UNITED STATES
NUCLEAR REGULATORY COMMISSION
WASHINGTON, D. C. 20555

OCONEE NUCLEAR STATION, UNIT NO. 1

AMENDMENT TO FACILITY OPERATING LICENSE

SAFETY EVALUATION BY THE OFFICE OF NUCLEAR REACTOR REGULATION
SUPPORTING AMENDMENT NO. 78 TO FACILITY OPERATING LICENSE NO. DPR-38

CORE PROTECTION
SAFETY LIMITS

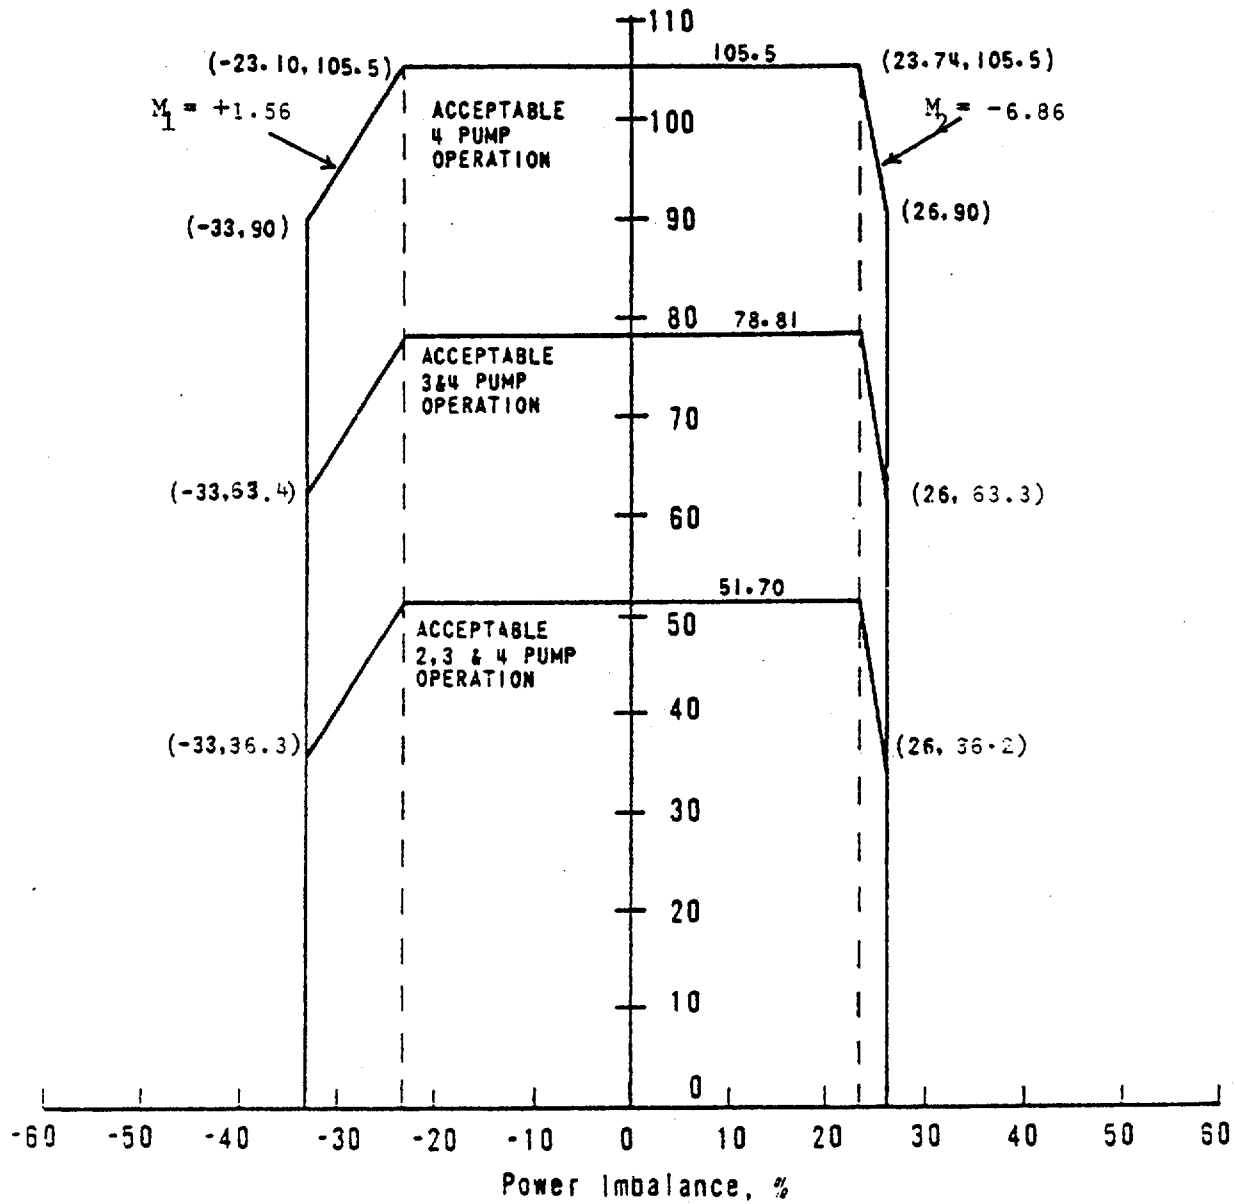
These amendments revise the core protection safety limits, protective system maximum allowable setpoints, control rod position limits, operational power imbalance envelope and axial power shaping rod position limits for Unit 2 consistent with extending the duration of the Unit's present operating cycle from 297 ± 10 to 363 effective full power days. Editorial changes have been included as discussed and accepted by your staff.

The TS would be revised to establish new reactor protection system limits and set points to ensure operation of the core within the prescribed DNB and accident limits such as peak clad temperature. The TS curves (which are acceptable) were derived following the methodology of B&W Topical Report BAW-10121 entitled RPS Limits and Set Points, June 1978.

ROD POSITION LIMITS
FOR FOUR-PUMP OPERATION
From 250 \pm 10 EFPD To 307 EFPD
OCONEE 2
OCONEE NUCLEAR STATION
Figure 3.5.2-1B2

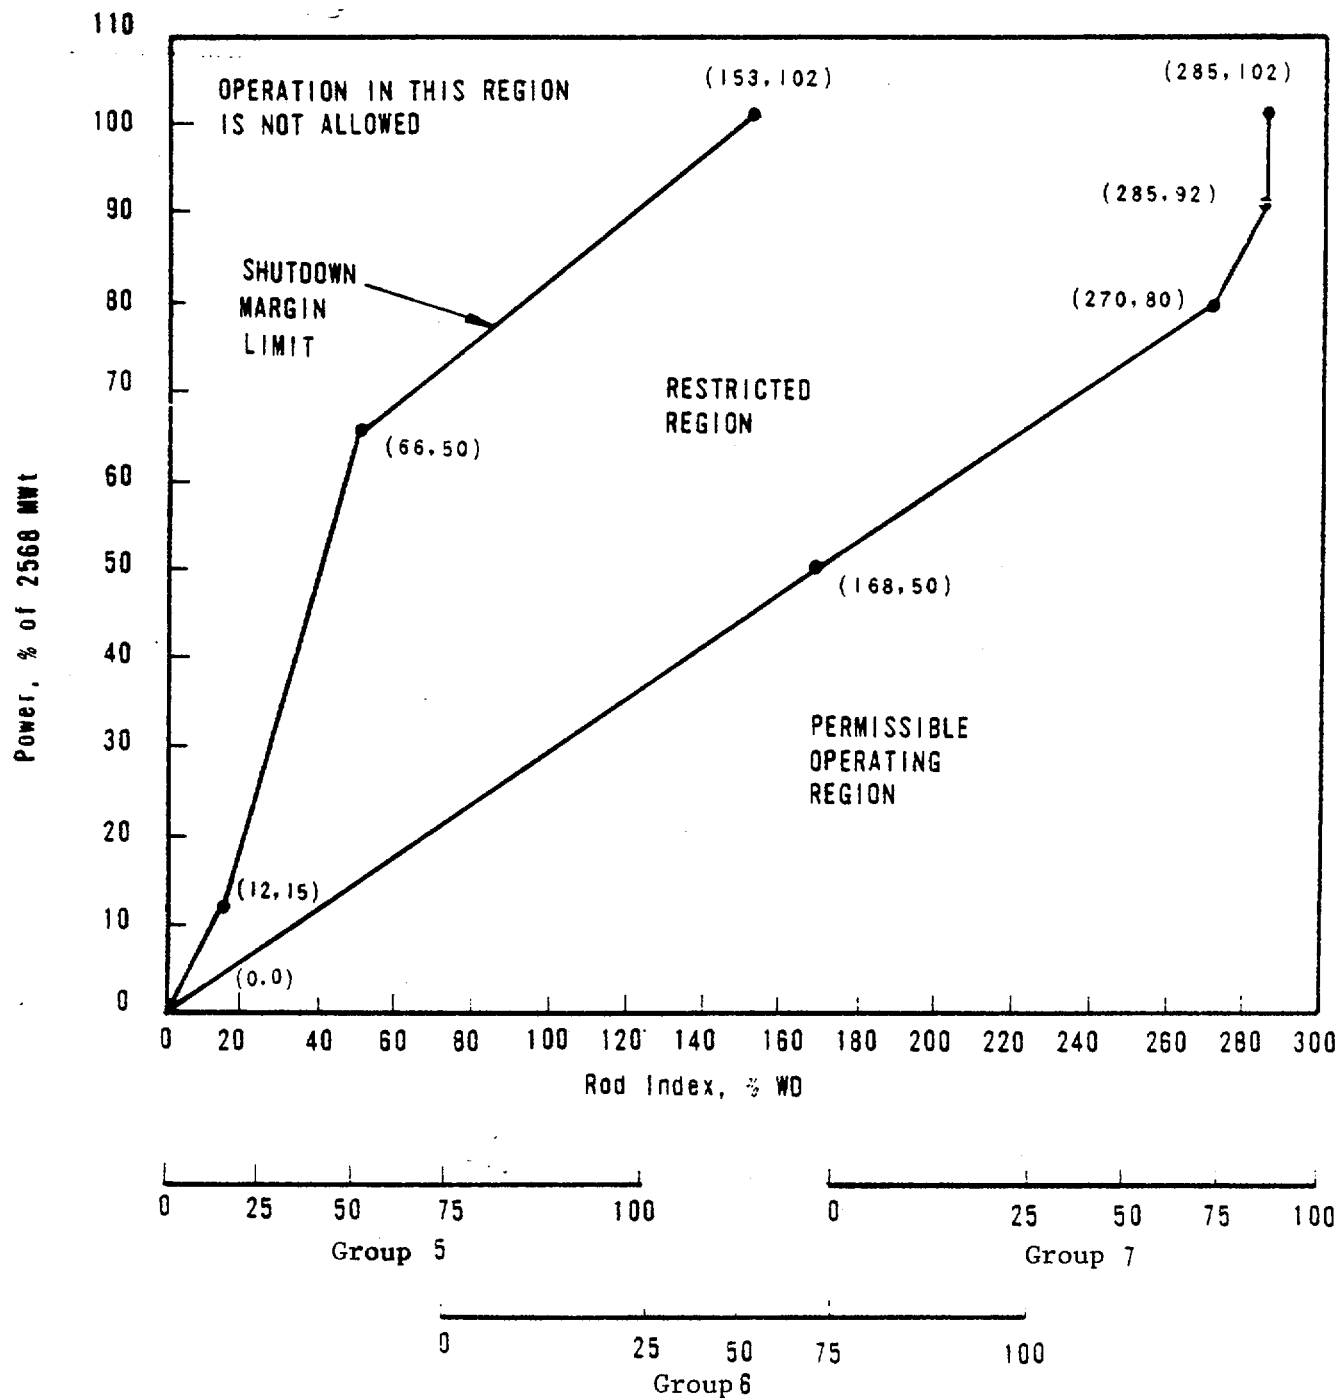
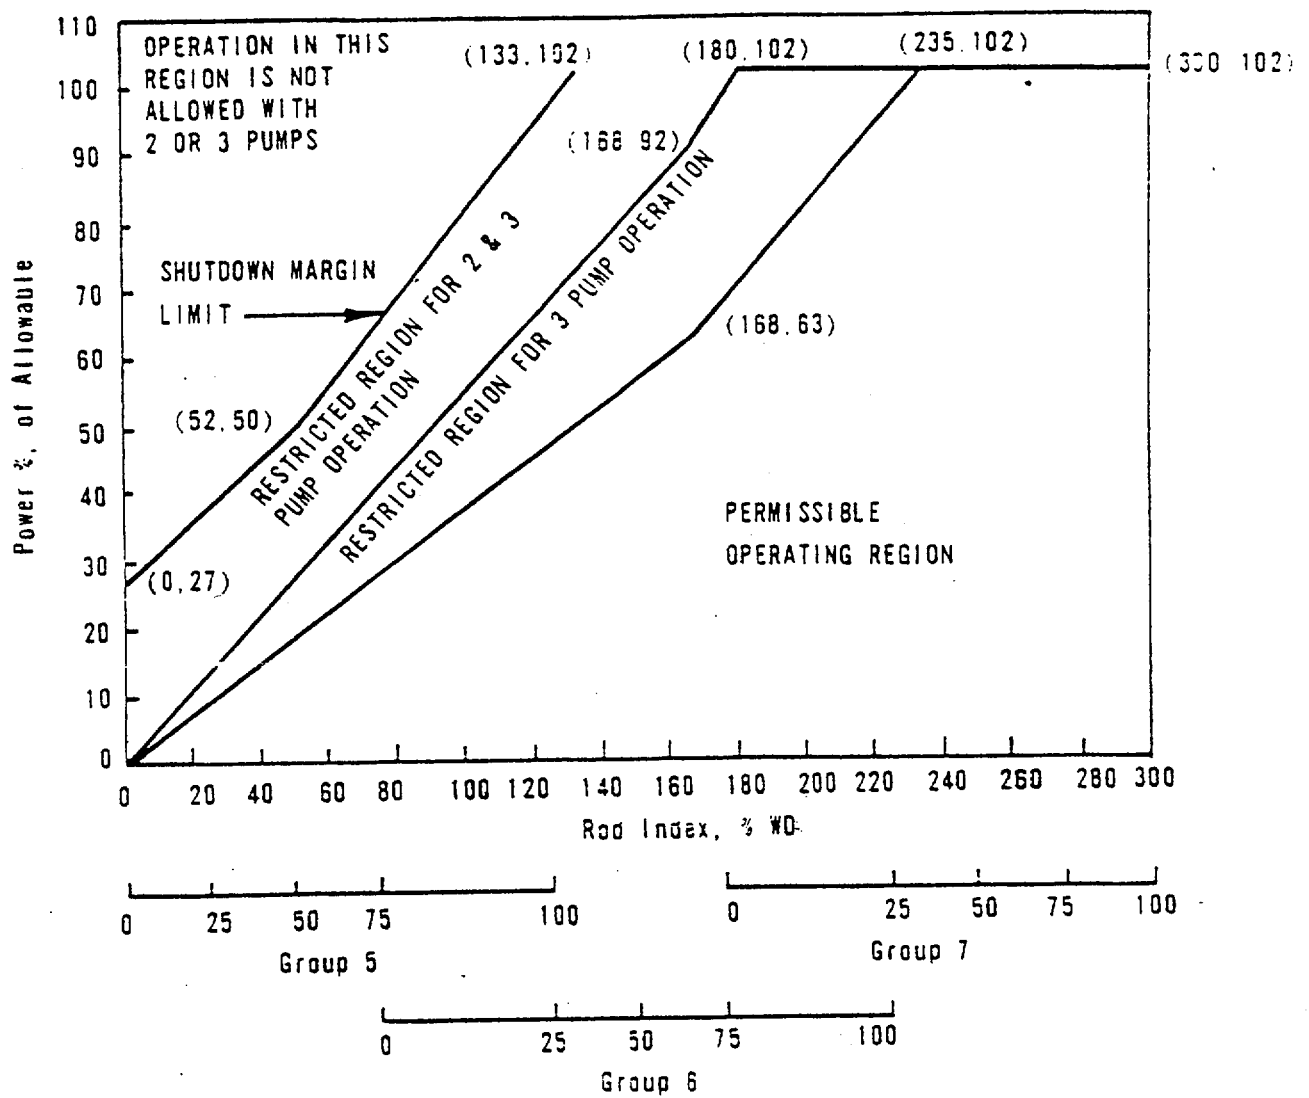
ROD POSITION LIMITS FOR
FOUR PUMP OPERATION
FROM 297 TO 363 EFPD
UNIT 2
OCONEE NUCLEAR STATION

ROD POSITION LIMITS
FOR TWO AND THREE PUMP OPERATION
From 250 ± 10 EFPD to 307 EFPD
OCONEE 2
OCONEE NUCLEAR STATION
Figure 3.5.2-2B2

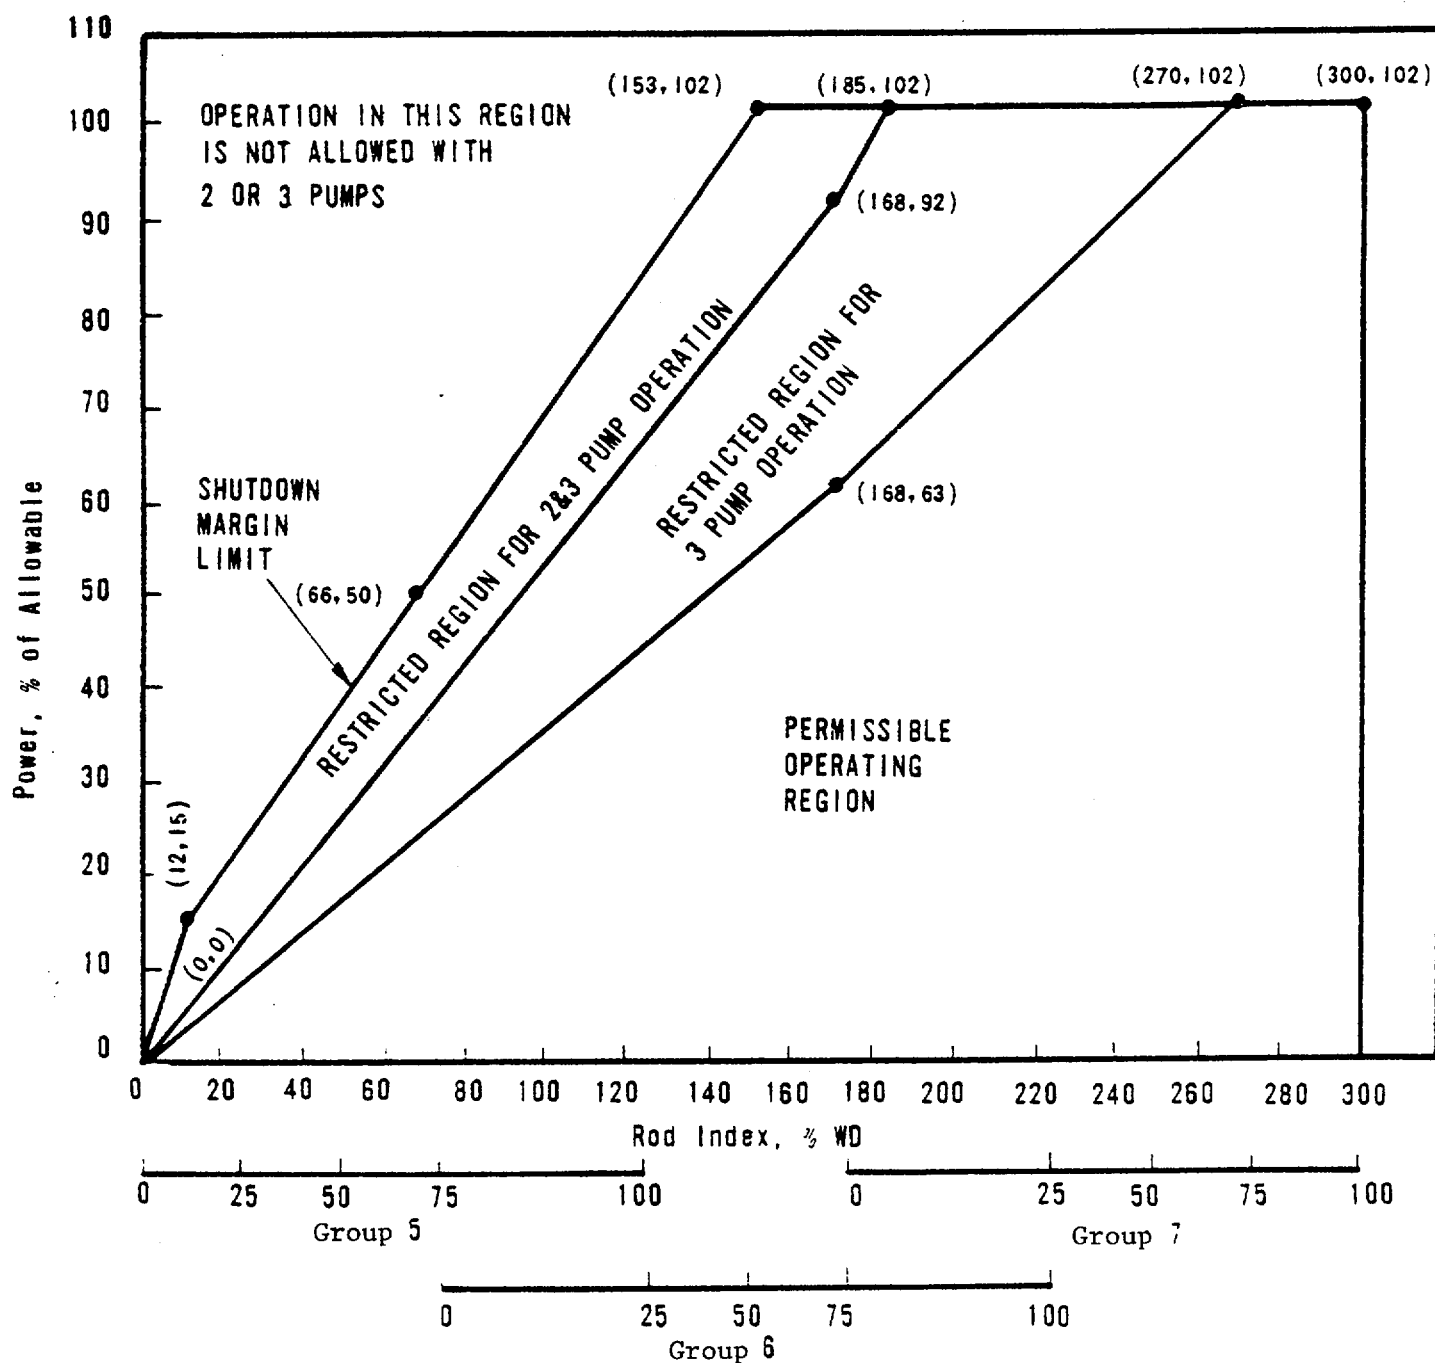
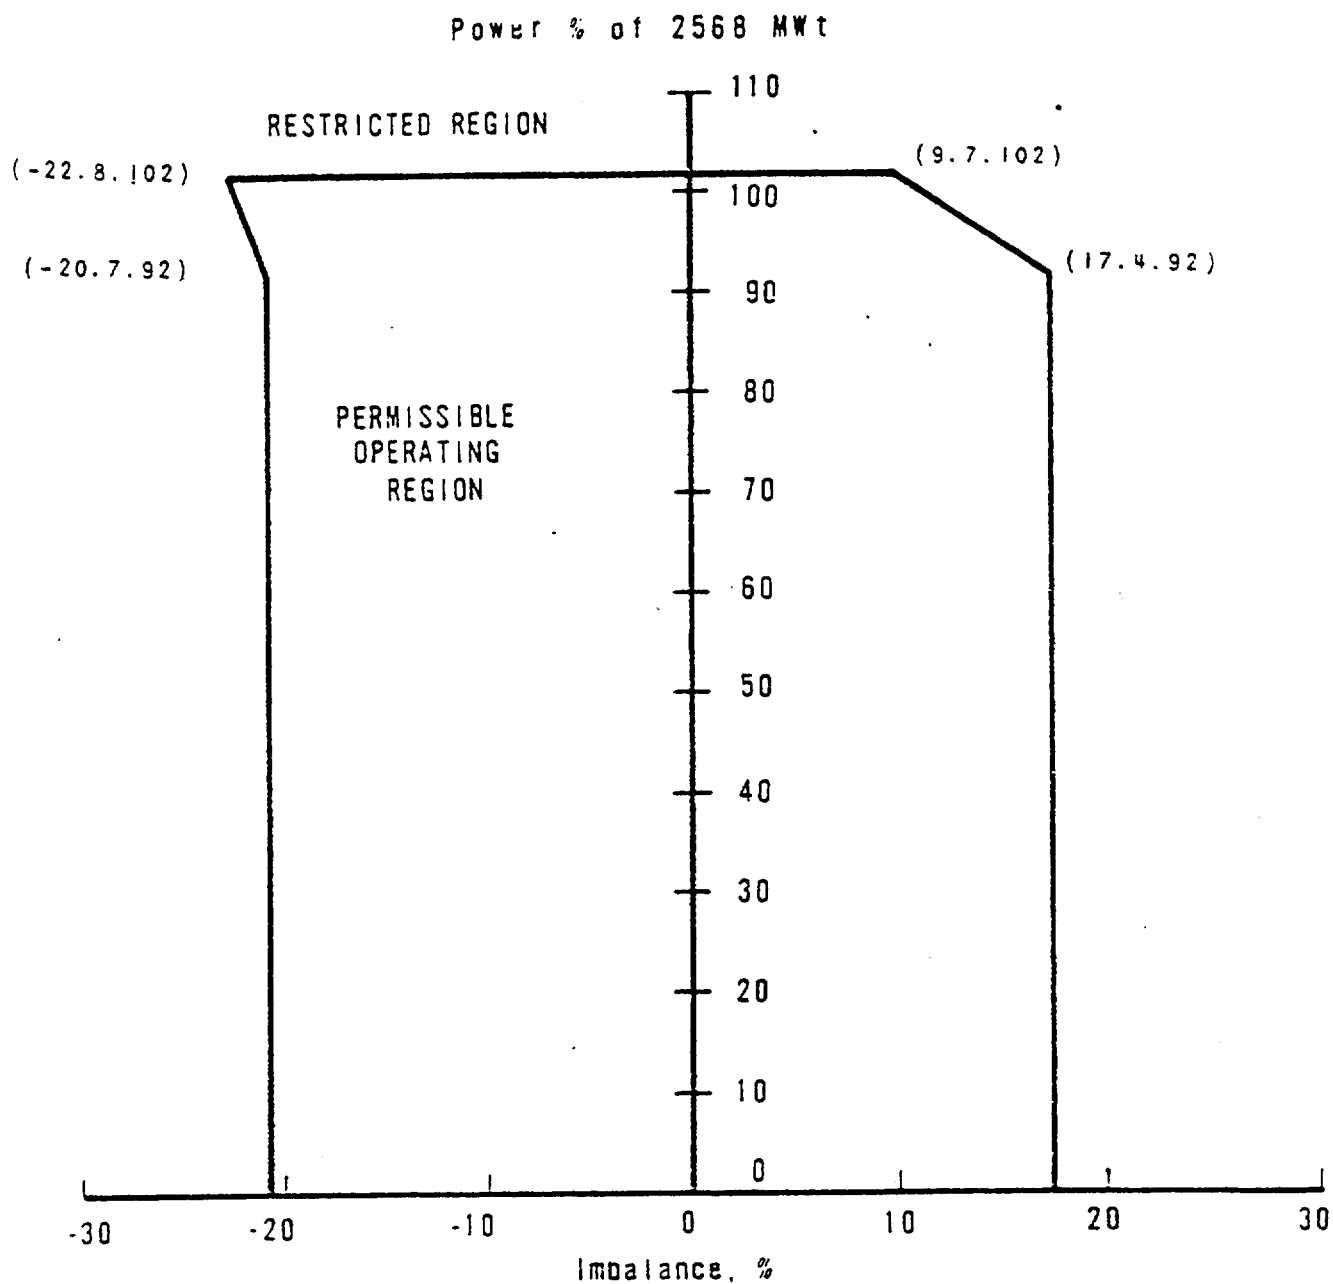
ROD POSITION LIMITS FOR TWO
AND THREE PUMP OPERATION
FROM 297 to 363 EFPD
UNIT 2
OCONEE NUCLEAR STATION
